Access Compliance Report

Public Rights-of-Way

(Curb Ramps)

Intersection ID: N/A	Main Street: BROOKHILL_RD	Cross Street: N/A	Location: NE
ADA ID: 9599C5F28592	Ramp Type: PerpDiag	Initial Pass/Fail: Fail	Overall Compliance: No
Codes/Mitigation Info/Possible Solution		Field Measurements/Component Compliance	
Severity Score: 8.75

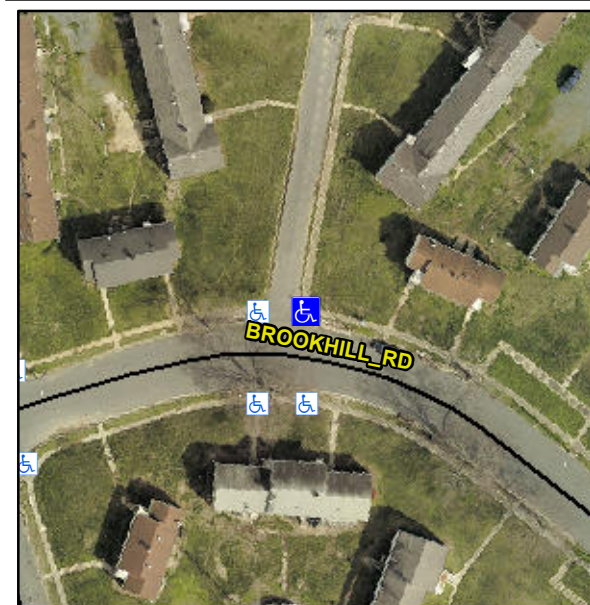
R304.5.1

Compliance	Description	Data	Compliance	Description	Data
N/A	Ramp Length (in)	48.0	Yes	Ramp Slope (%)	5.3
No	Ramp Width (in)	47.0	Yes	Ramp XSlope (%)	1.8
N/A	Flare Type LT	N/A	N/A	Flare Type RT	N/A
N/A	Flare Slope LT (%)	N/A	N/A	Flare Slope RT (%)	N/A
N/A	Flare Traversable LT?	N/A	N/A	Flare Traversable RT?	N/A
N/A	Landing Length (in)	N/A	N/A	DWS Provided?	N/A
N/A	Landing Width (in)	N/A	N/A	DWS Contrast?	N/A
N/A	Landing Slope (%)	N/A	N/A	DWS Length (in)	N/A
N/A	Landing X Slope (%)	N/A	N/A	DWS Full Width?	N/A
N/A	Landing Curb? (Y/N)	N/A	N/A	DWS Offset (in)	N/A
N/A	Shared Landing?	N/A			
N/A	Gutter Ponding?	N/A	N/A	Gutter Slope (%)	N/A
N/A	Gutter Lip Ht (in)	N/A	N/A	Gutter X Slope (%)	N/A
N/A	Painted X Walk1?	No	N/A	Painted X Walk2?	No
	X Walk 1 Direction	To W		X Walk 2 Direction	To S
N/A	X Walk 1 Width (in)	N/A	N/A	X Walk 2 Width (in)	N/A
	X Walk 1 Slope (%)	2.9		X Walk 2 Slope (%)	1.1
	X Walk 1 X Slope (%)	6.2		X Walk 2 X Slope (%)	5.4

Remove & Replace Curb Ramp With Two New Directional Ramps or Equivalent.
